Subject: WIND NOISE AT REAR DOOR QUARTER GLASS	Bulletin No.: 09-024/18
	Last Issued: 05/10/2018

2014-2016 Mazda6

2017 Mazda6 vehicles with VINs lower than JM1GJ*****153693 (produced before Dec. 5, 2017)

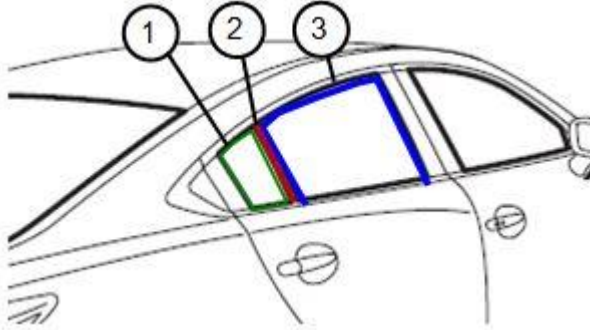
Some vehicles may exhibit wind noise at rear door quarter glass when driven at high speeds. This is caused by air leakage from the gap between rear sash molding, rear door glass run channel, rear door glass guide and rear door quarter glass guide.

- A rubber seal on rear door quarter glass guide has been extended.
- A rubber seal has been added to rear door glass guide.
- The shape of rear door glass run channel has been changed.

1. Verify customer concern.
2. Replace the rear door quarter glass guide (1), rear door glass guide (2), and the rear door glass run channel (3) at affected side(s) with modified ones according to the instructions on MGSS (REAR DOOR QUARTER GLASS REMOVAL/INSTALLATION).
